Company	Trenz Electronic GmbH
ACN Number	ACN-20240206
Title	CameraLink removal
Subject	Upcoming Changes
Issue Date	2024-02-07

Affected Product
TE0701-07*

2.2 #2 Changed FMC connector (J10) from LPC to HPC to use connections from CameraLink Connector (J3).

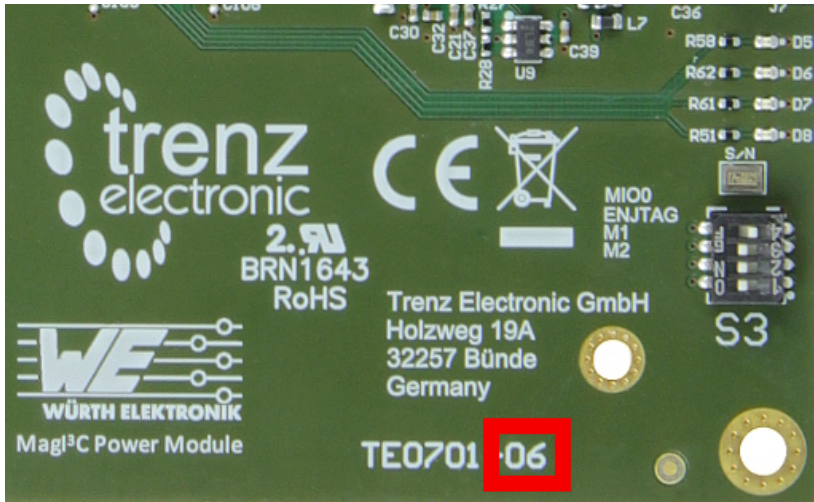
Type: Schematic Change

Reason: CameraLink connection usage.

Impact: None. HPC connector is backward compatible to LPC connector.
